DECLARATION OF THE RECORD OF DECISION

U.S. DOE Hanford 200 Area
Hanford Site
Benton County, Washington

This decision document presents the selected Interim Remedial Action (IRA) for the U.S. Department of Energy (U.S. DOE) Hanford 200-UP-1 Operable Unit (OU), 200 Area, Hanford Site, Benton County, Washington. The IRA was chosen in accordance with the *Comprehensive Environmental Response, Compensation, and Liability Act of 1980* (CERCLA), as amended by the *Superfund Amendments and Reauthorization Act of 1986* (SARA), the *Hanford Federal Facility Agreement and Consent Order* (also known as the Tri-Party Agreement, or TPA), and to the extent practicable, the *National Oil and Hazardous Substances Pollution Contingency Plan* (NCP). This decision is based on the Administrative Record for this site.

Figure 2. Location of 200-UP-1 Groundwater Operable Unit.

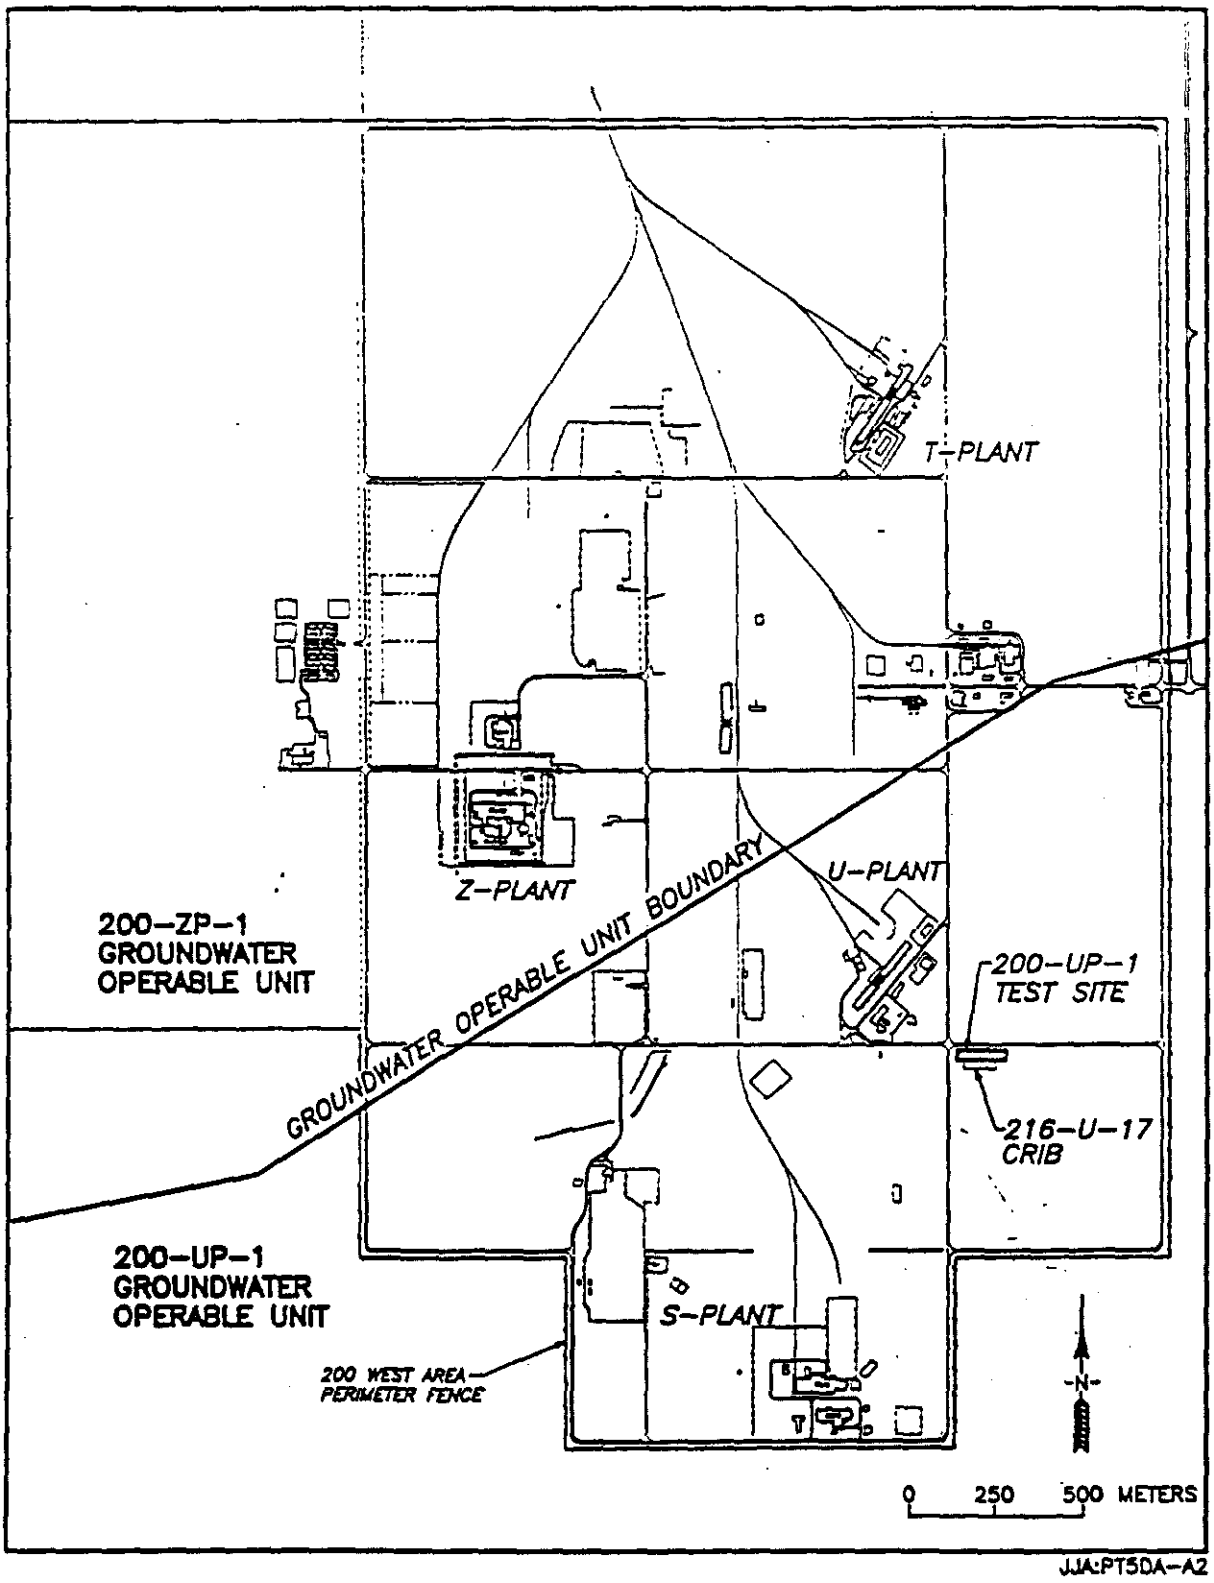
Page 3, Figure 2

Figure 2 has an unacceptable lack of detail. All groundwater monitoring wells should be shown along with measurements of the contaminants. Additional figures should be shown to map each of the plumes individually. The carbon tetrachloride plume is not shown on Figure 2.

The maximum concentrations for each of the contaminants are not specifically shown on Figure 2.
